Title: Applicant Response to Hertfordshire
County Council LLFA Consultation
Response

Date: 25th July 2024

- 1.2 A planning application (Reference: 3/24/0966/OUT) was submitted for the following:
- "Outline planning application for development of up to 600 dwellings (C3), elderly accommodation (C3), Mixed Use Local Centre (including flexible use E, F and Sui Generis), First School, informal and formal open space, associated works and infrastructure including a new access from the A507 and pedestrian bridge over the A10, with all matters reserved except access."*

- 1.5 This technical note provides a formal response to the comments received from HCC LLFA in its consultation response.

TITLE:
LAND DRAINAGE PLAN

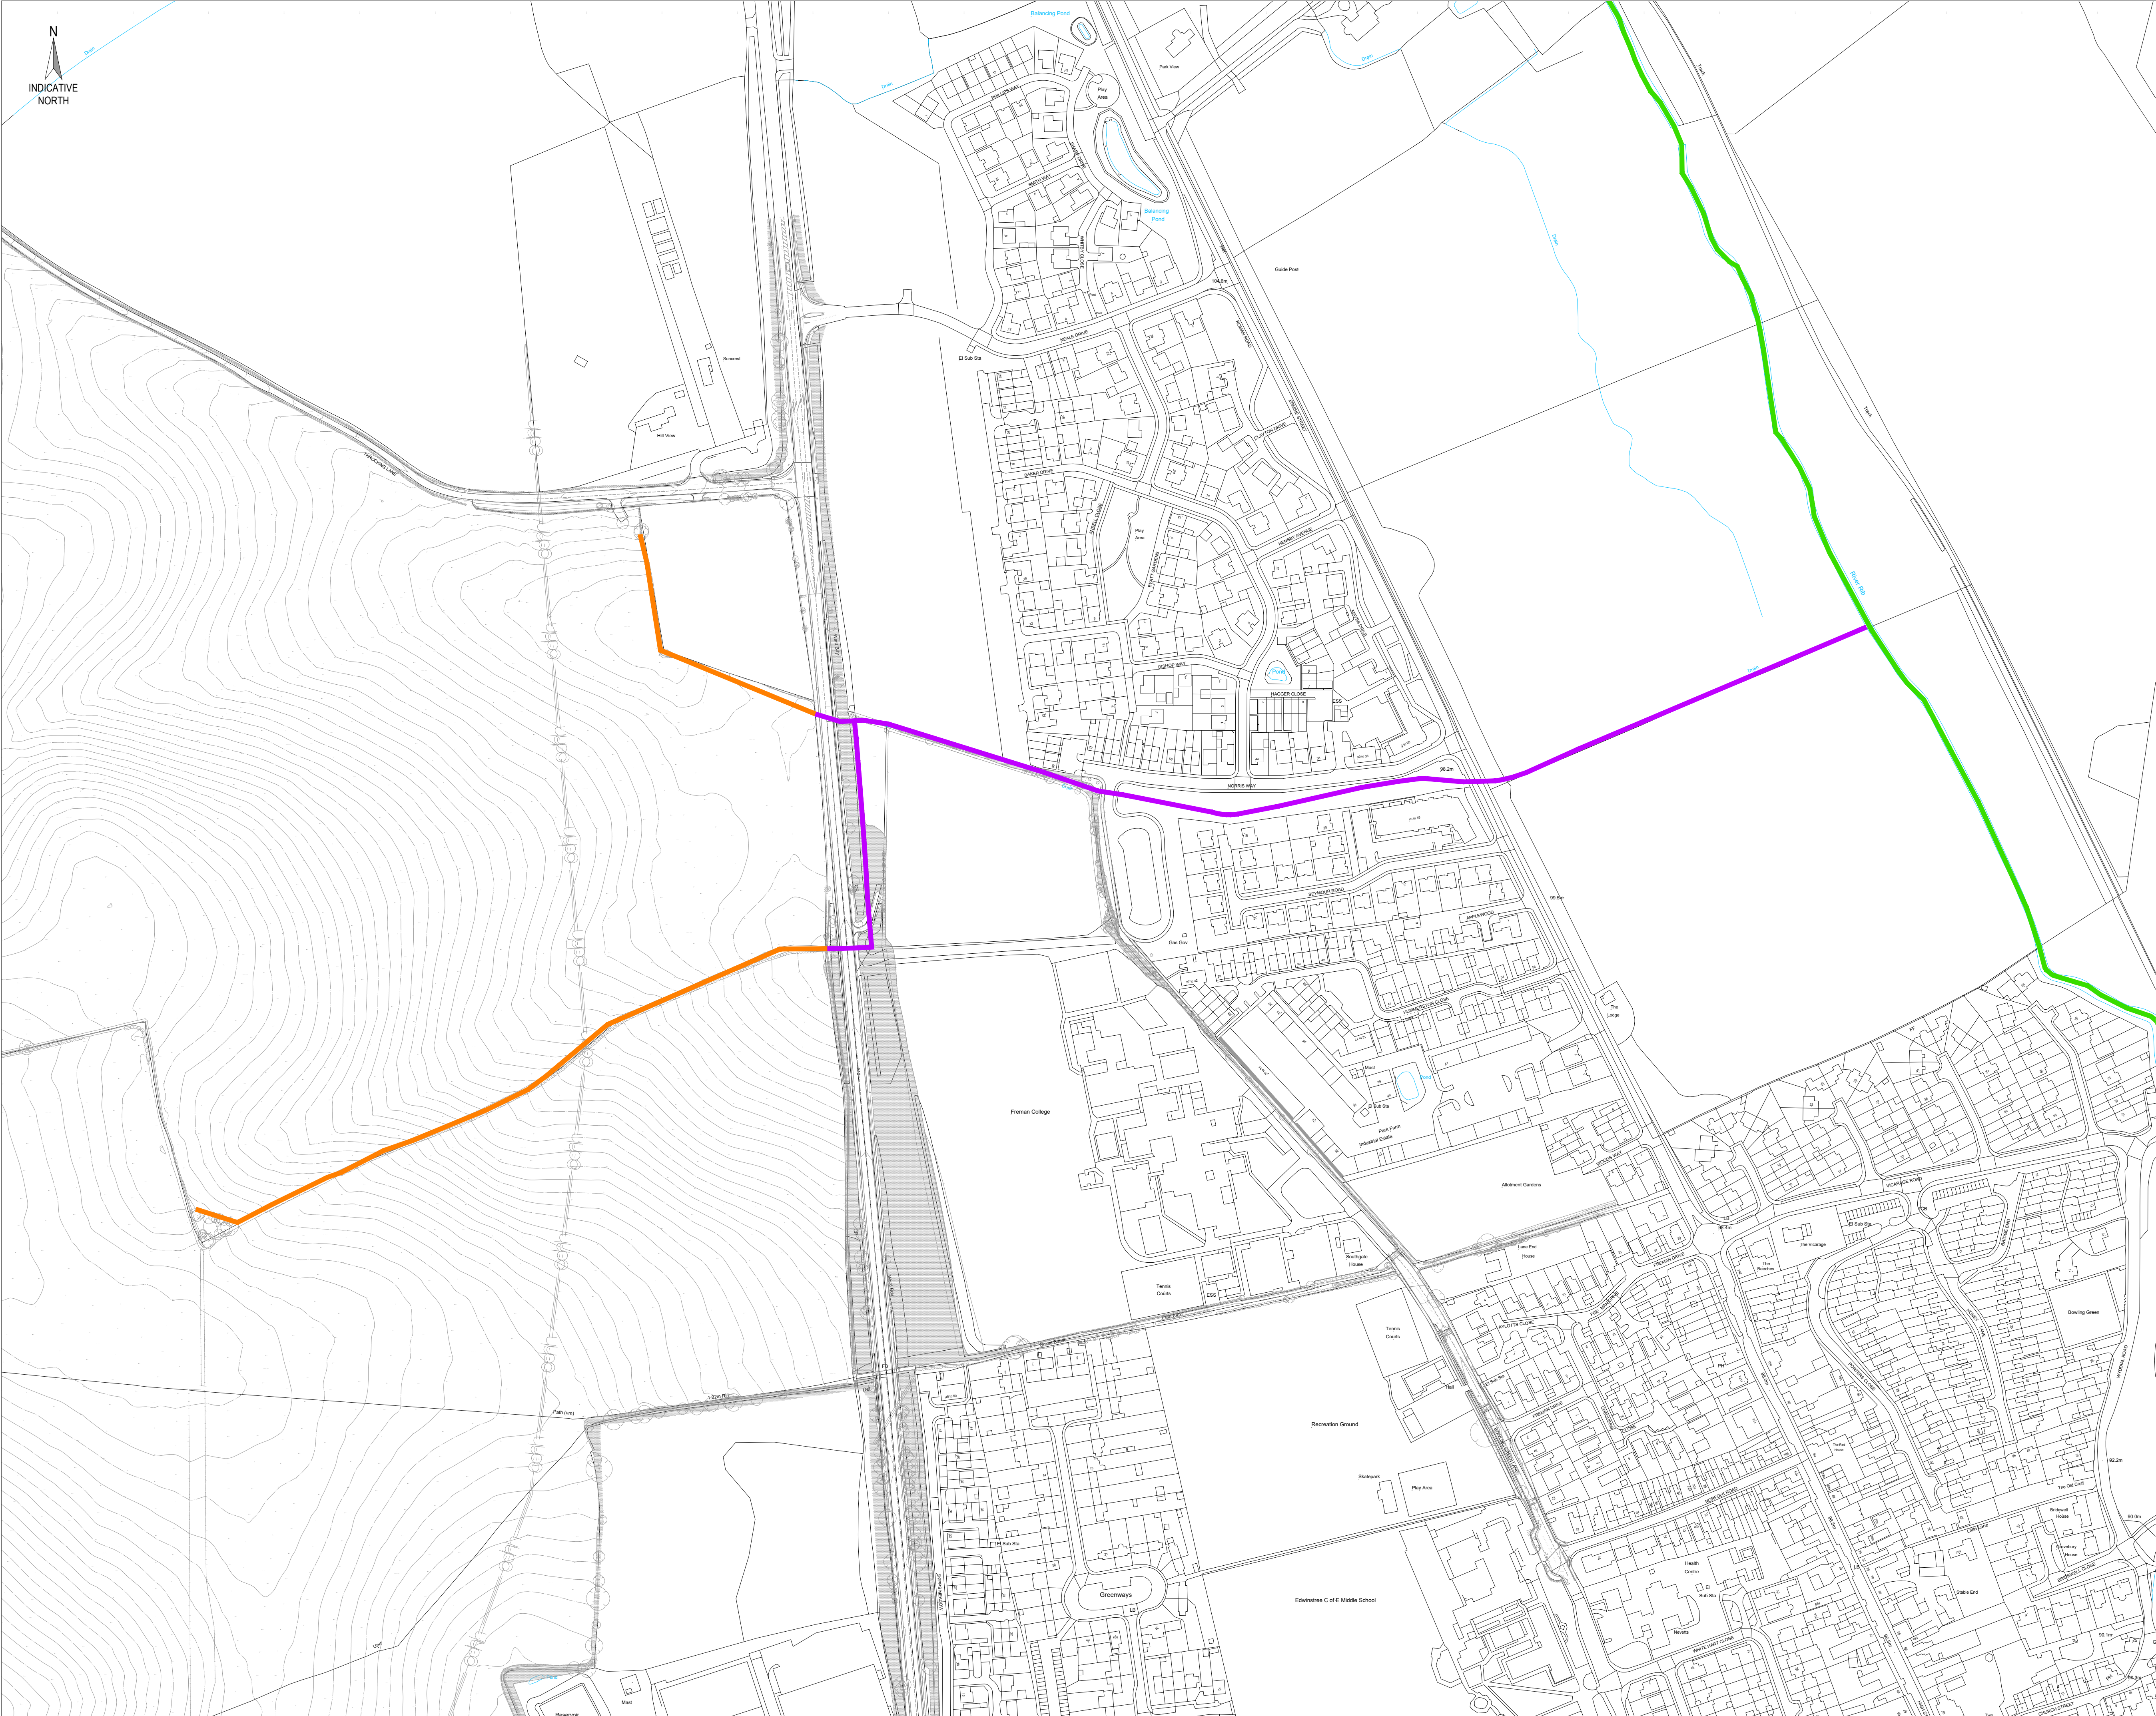
No.	LLFA Comment	Applicant Response
7	OBJECTION Drawing required to show where existing drainage network and outfall/s are, plus confirmation if they will be retained or removed. Whilst a plan of the current land drainage network is provided, the LLFA need confirmation if this land drainage will be removed as part of the development and a drawing showing the current catchment areas that drain to each location within the proposed development site boundary. It must be shown that if land drainage is cut off as part of the works, a continuation of that drainage be provided without increasing the risk of flooding.	The proposed site is split into two fields, existing land drains have been identified within the northern field and the neighbouring land to the north-west of the site. No land drainage is shown to be present within the southern field. Where possible any existing land drainage within the site will be retained and accommodated as part of the development proposals. Where the development impacts the existing land drains and the drains are no longer required they will be abandoned and removed. Any land drains serving the neighbouring land which passes through the site will be maintained. Where the route of these drains is impacted by the development, they will be diverted to accommodate proposals. The development proposals will ensure that the development proposals do not increase the risk of flood risk to the site or the surrounding area. A plan of the existing land drainage is included in Appendix C. This shows the sections of the existing drainage which will be maintained, removed or diverted.

TITLE:
DRAINAGE DITCH CONNECTIVITY PLAN

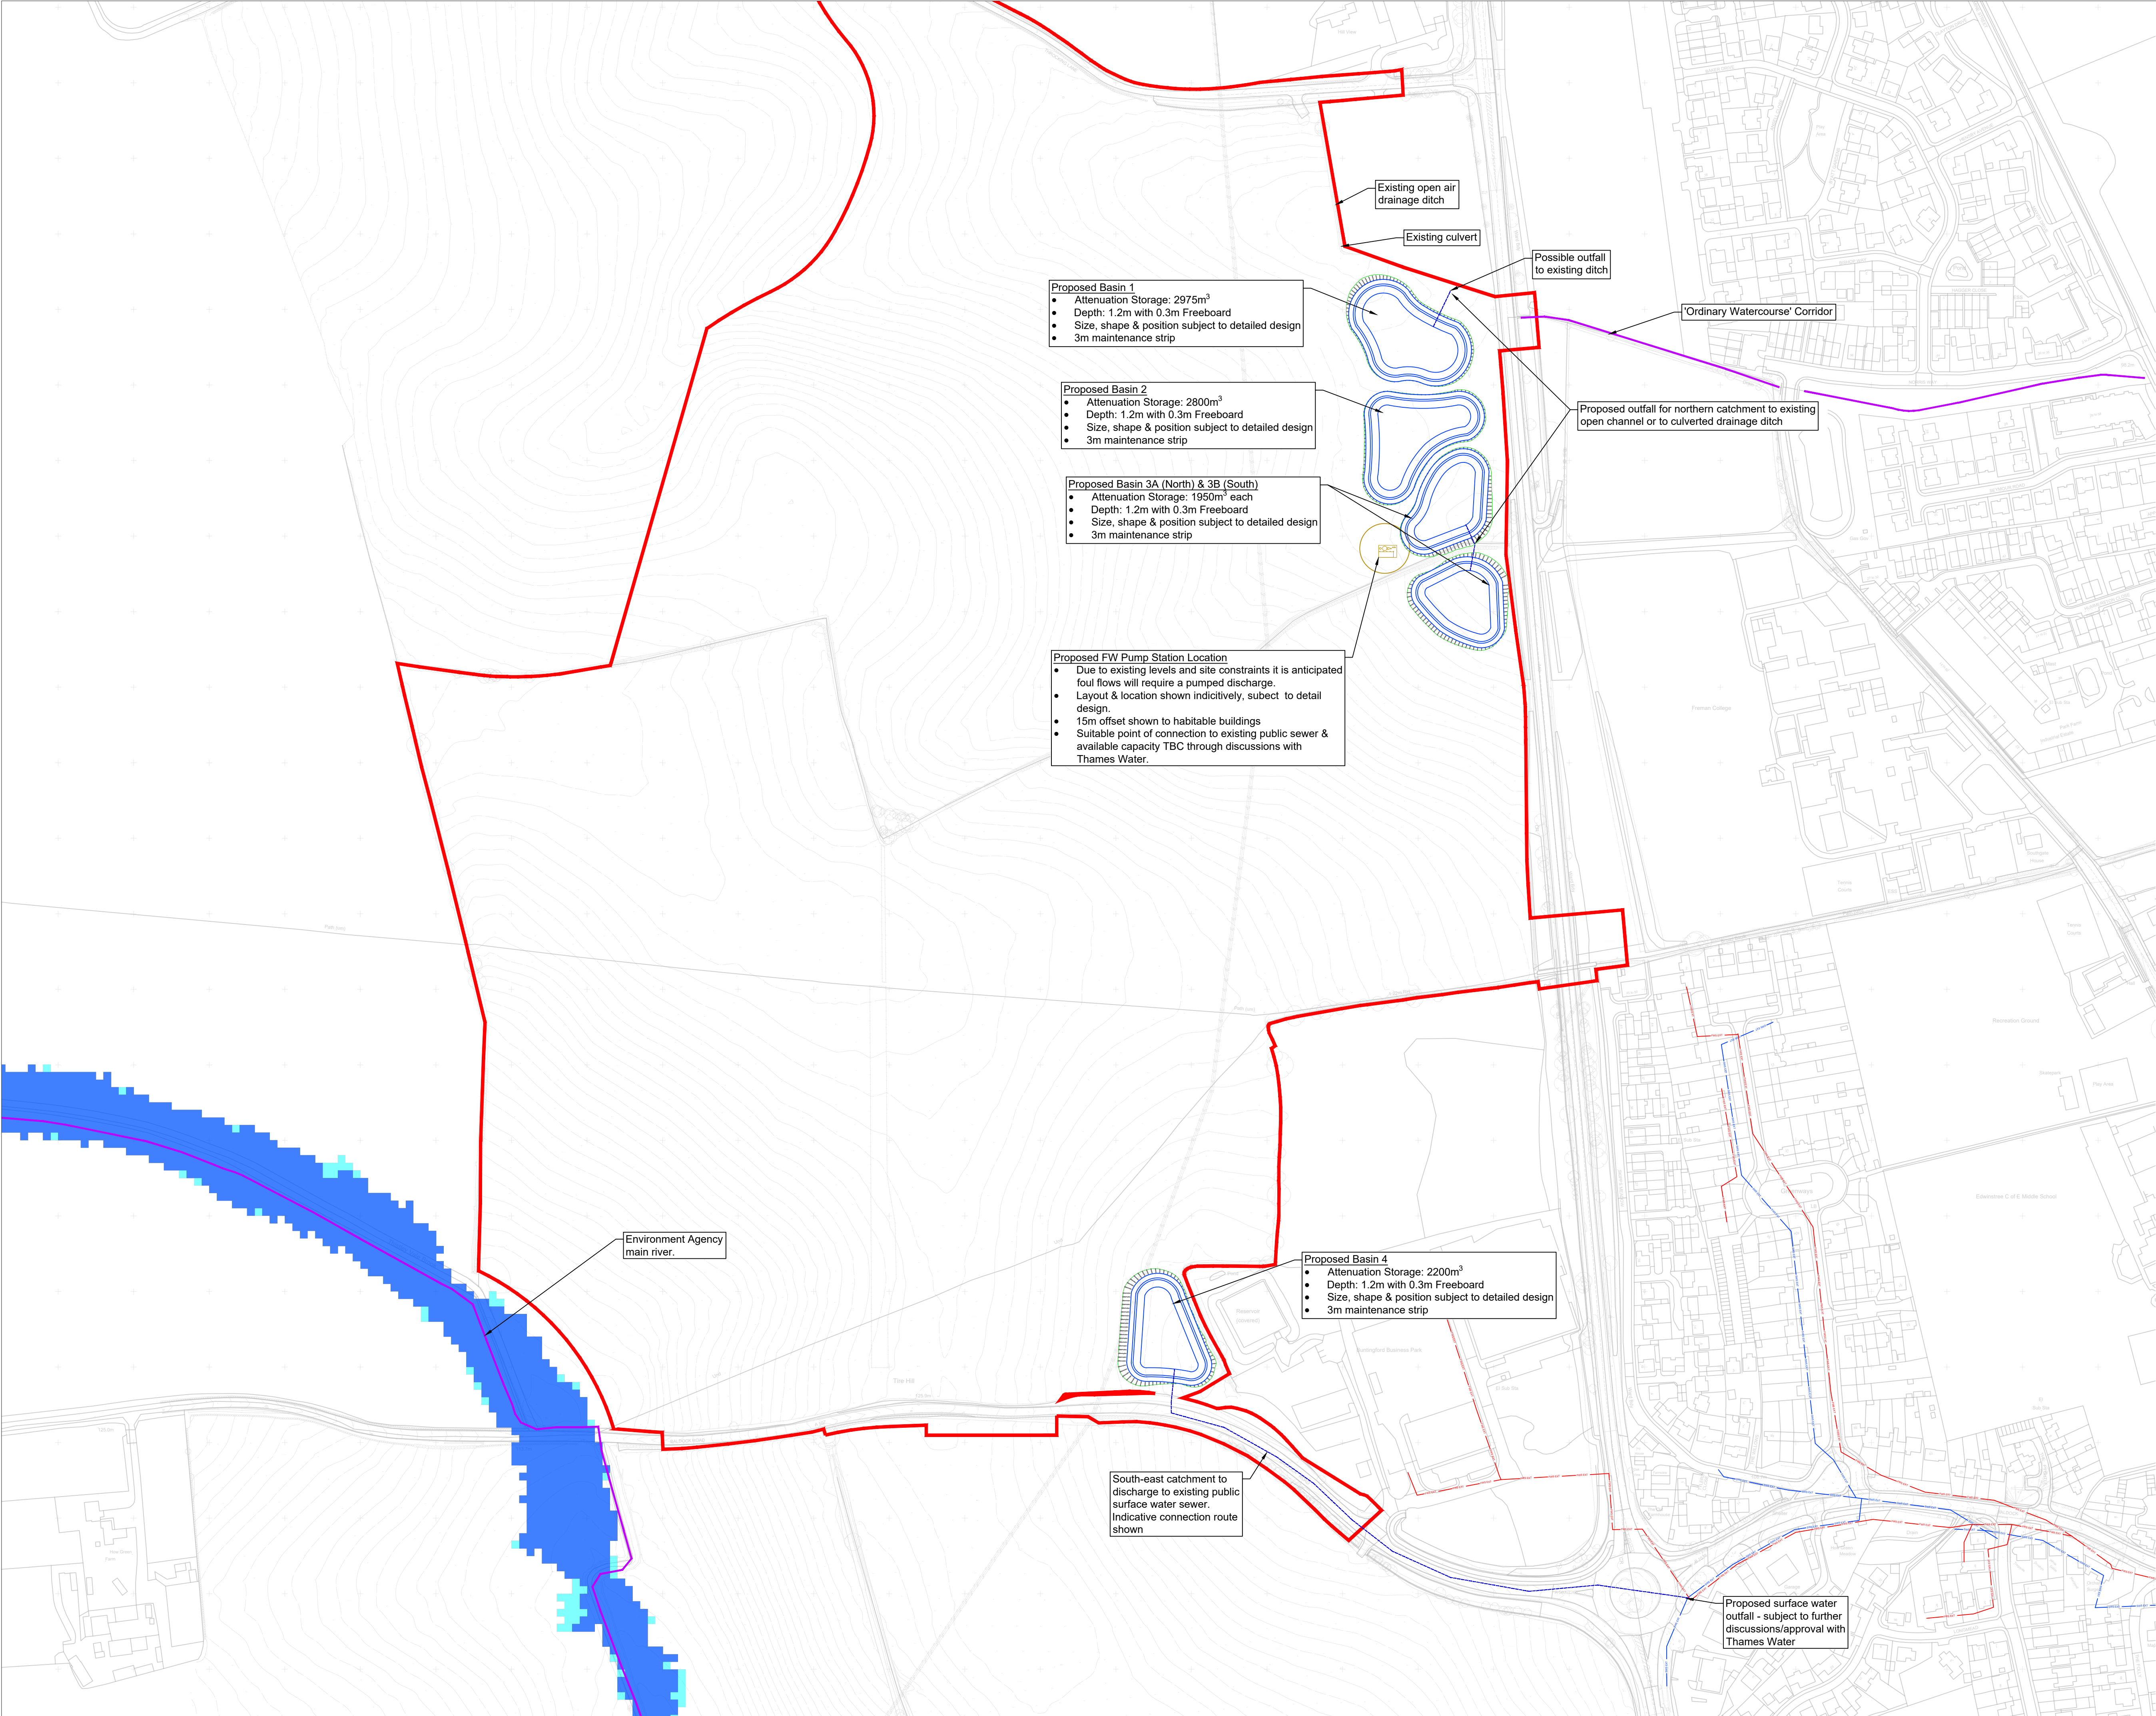
8	OBJECTION Surface watercourse – does it connect to the wider network and is there permission and there are agreed access locations for proposed outfalls with the riparian owner? Drainage system proposed to discharge to a ditch which connects into an ordinary watercourse, the condition of this watercourse to accept a discharge and evidence that it is connected to the wider watercourse network should be provided.	The vast majority of the existing greenfield site drains to the north-east corner of the site, where existing drainage ditches convey flows offsite beneath the A10, with the ditch continuing to the east before converging with the River Rib. The development drainage strategy aims to mimic the existing drainage regime of the greenfield site with flows discharged at a restricted pre-development greenfield rate for all events up to the 1 in 100 +climate change. It is considered that the development drainage strategy will be providing a betterment on the existing greenfield regime with discharge from the site being restricted compared to the current free discharge. It is therefore considered that the existing drainage ditches are in an acceptable condition and are capable of accommodating the discharge from the development as these ditches are currently serving the existing site effectively with the development discharge to provide a betterment on the existing scenario. A plan showing the downstream connectivity of the existing watercourse is included in Appendix D.
